**REQUEST FOR INFORMATION
FOR
COUNTY OF SAN MATEO**

HALF MOON BAY AIRPORT ELECTRICAL VAULT AND GENERATOR PROJECT

**COUNTY PROJECT NO. AH035
PROJECT FILE NO. E5079 (Project)**

SUBSTRUCTURE

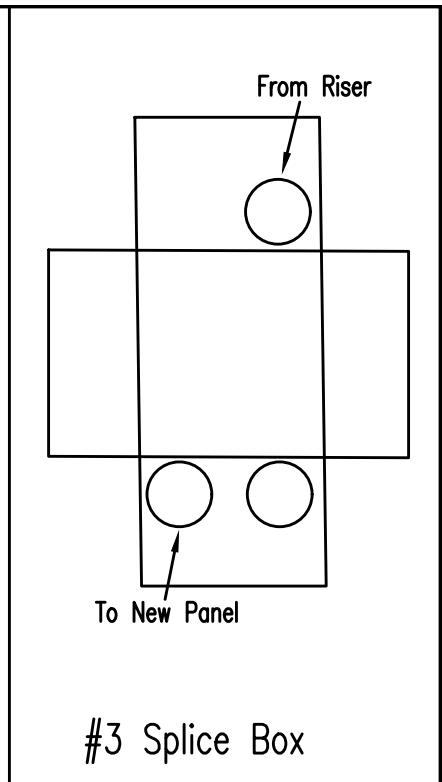
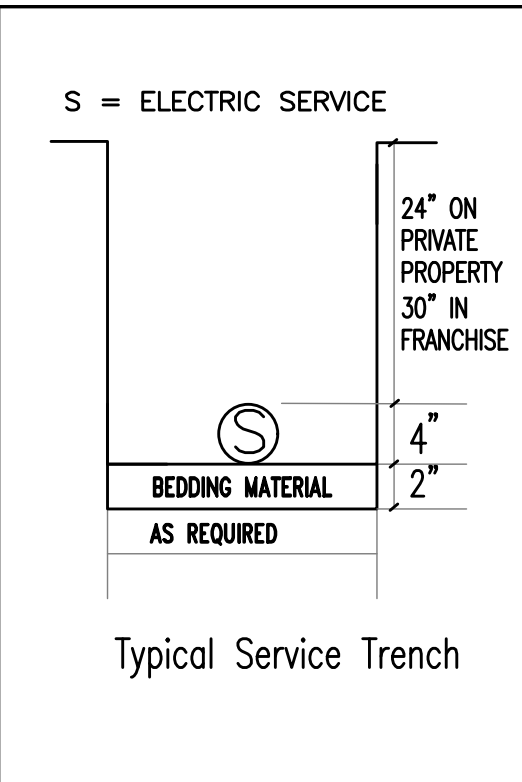
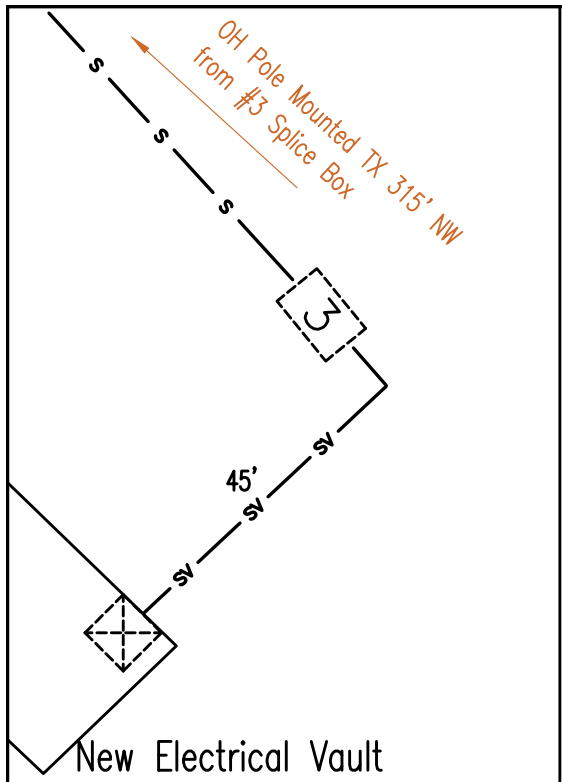
Q8. During the pre-bid meeting the question was asked if the owner was in receipt of an approved substructure package from PGE. The response was yes, and that the PGE rep is Liz Freidman. The contractor takes exception to two parts of this response. First – Liz Freidman has been promoted to a supervisory position and is no longer in the PM capacity, so we ask for the name of the current PGE representative assigned to this project. Second – since there is an approved substructure package from PGE, we ask for the PGE Project PM number and to provide said drawings as part of the bid documents. If either of the requests are unable to be provided, we request that the owner confirm the contractor is not to be held responsible for costs associated with any PGE related delays. Additionally, we ask the owner to confirm that any cost escalations such as wage rates, extended overhead and the like will be the responsibility of the owner.

R8. The new PG&E contact for the project is Katie Townsend, with contact number (650)232-9664 and email addresses and k2tm@pge.com. Please refer to page TS L-102-1 (rev) enclosed with Addendum No. 3. A Substructure Drawing from PG&E has also been provided for the project and is attached to this RFI document for reference.
